Re: STB Finance Docket No. 35724 Sub No. 1, California High-Speed Rail Authority—Construction Exemption—In Fresno, Kings, Tulare, and Kern Counties, California

This letter is in response to comments received from the freight railroad BNSF Railway Company (BNSF). The BNSF sent a comment letter on the Fresno to Bakersfield (F-B) Final Environmental Impact Report/Environmental Impact Statement (EIR/EIS) to the California High-Speed Rail Authority (CHSRA or Authority), Federal Railroad Administration (FRA), and the Office of Proceedings of the Surface Transportation Board (STB). (Letter from Richard E. Weicher, BNSF to Mark McLoughlin (CHSRA), David Valenstein (FRA), Cynthia Brown (STB) [May 6, 2014].) The letter was received by the Authority on May 7, 2014, after its Board of Directors had certified the environmental document and approved the project from the City of Fresno south to 7th Standard Road outside of the City of Bakersfield. The comments on the Final EIR/EIS are taken into consideration for the decisions by the FRA and STB. The STB Office of Environmental Analysis has informed the Authority that it expects a response to the BNSF to be filed with its Office of Proceedings w

CONTRACT NO.
HSR 06-0003
 DRAWING NO.
SV2495
 SCALE
AS SHOWN
 SHEET NO.
6 OF 11

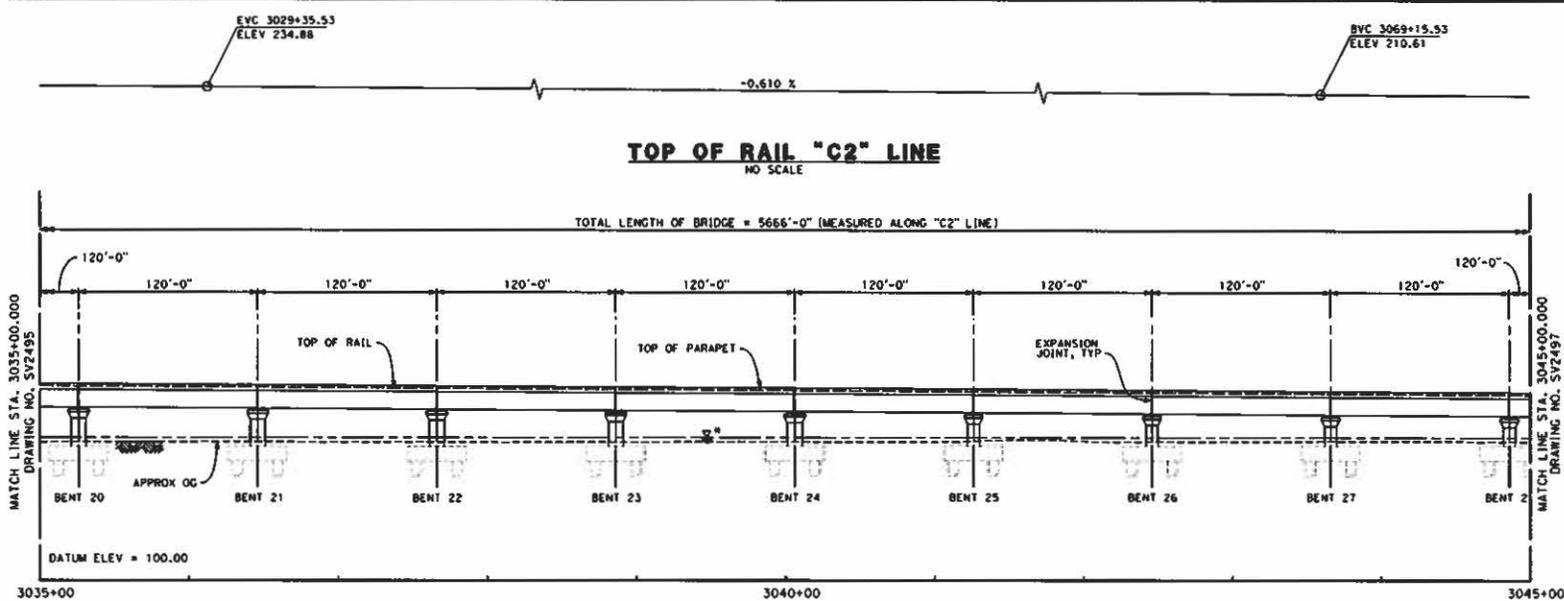
(3) CHSRA recently informed BNSF that it wants to relocate BNSF's right-of-way in three or four locations, but they did not provide detail. There is no agreement in place between BNSF and CHSRA contemplating such use of BNSF's property, and the FEIR/FEIS is notably deficient in addressing the issues and assessing impacts. For example, as part of the Preferred Alternative's route through Fresno, Kings, and Kern counties, the FEIR/FEIS states that BNSF railway tracks will need to be realigned. Specifically, at page 2-64, the EIS states that "[a]pproximately 5.5 miles of BNSF Railway tracks would be realigned ... to accommodate the HST alignment" through Fresno county. Likewise, the FEIR/FEIS states that "[a]pproximately 0.3 mile of BNSF Railway tracks would be realigned" in Kings county, and "[a]pproximately 4 miles of BNSF Railway tracks would be realigned" in Kern county. See FEIR/FEIS, at pages 2-64 to 2-65. The Alignment Plans provided in Volume III of the FEIR/FEIS appear to identify the location of some of these proposed realignments. See e.g., Appendix 3.1-A, at 91. At no point, however, does the FEIR/FEIS in Chapters 3.2 or 3.13 (those relevant to land use and transportation impacts) assess the impacts associated with the proposed realignment, including the timing/procedures to relocate the tracks and/or the impacts to BNSF's freight rail service as a result of re-location activities.

- In Kings County, the HST alignment would rejoin the BNSF Railway south of Corcoran, crossing over the BNSF Railway, SR 43, and the Tulare River on an elevated structure. The structure would reach a maximum height of approximately 45 feet to the top of the rail (Drawings SV2490 through SV2497, Appendix B).
